In October 2015, the *Greater Cambridge City Deal Executive Board* launched a formal public consultation, asking the public for its views on the best route for *a new bus & cycle-route between Cambourne and Cambridge*.

██████████ is a response to that consultation.

Madingley Road / A428 Cambourne to Cambridge Corridor Study  
Interim Report

**Figure 2 Consultation Route Summaries**

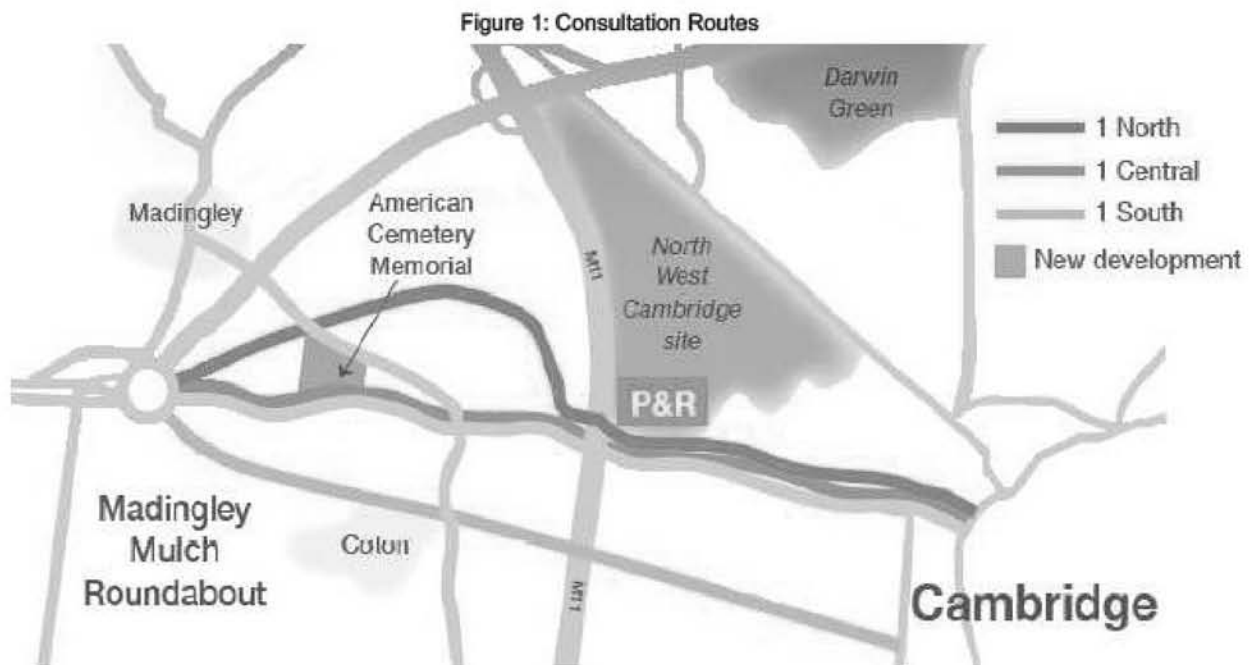
This route does not meet the objective to provide congestion free public transport serving the corridor, as it only provides east bound bus improvements and terminates at the congested Northampton Street Queens Road junction. Additionally the does it meet the objective to provide public transport to serve the city centre and other employment sites as an interchange at the existing park and ride would limit the connectivity with the West Cambridge and North West Cambridge development sites.

Madingley Road between the existing Park and Ride site and Northampton Street does not currently experience intensive congestion and the provision of a dedicated bus lane and improved cycle facilities is likely to fundamentally change the character of the street, with the loss of verges, trees and potentially hedgerows with little local benefit,

Area 1 South meets the objectives defined for the scheme to provide congestion free public transport along the corridor with public transport links to the west of the M11 and links to the city centre and the employment sites. As a suggested route it provides a quicker service into the city centre than the other options, plus it provides an improvement for west bound journeys not addressed by other options.

Figure 3:Area 1 Alternative

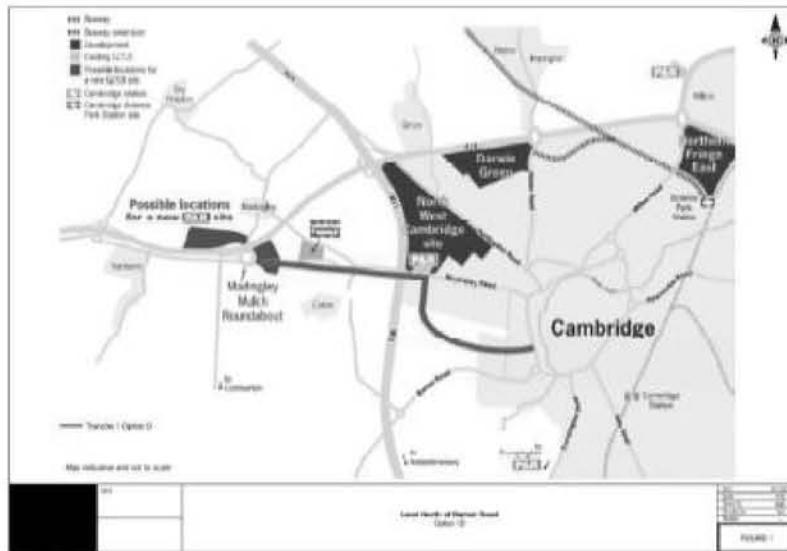
The Area 1 Alternative route would utilise existing infrastructure to the west of the M11 including the M11 junction itself. It is likely that some improvement to the junction would be required but more detailed investigation is needed to determine what would be required

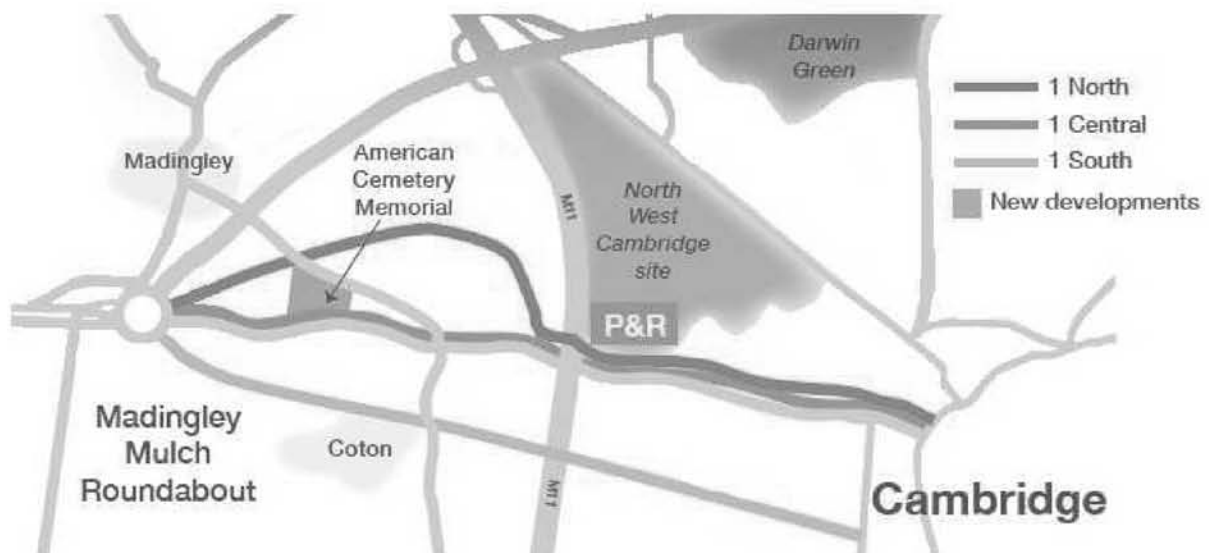
For a park and ride to be successful it needs to be close to the route from which it is diverting traffic, minimising the diversion required to reach it. The Harbourne site is ideally located immediately to

the north of Cambourne, with direct access from the existing interchange on the A428. The [redacted] proposals can therefore facilitate a park and ride in the most effective and efficient location. The proximity of the facility to Cambourne will also maximise use by existing local residents. In it's note on the [redacted] proposals of 2nd October 2013, the County advised that:
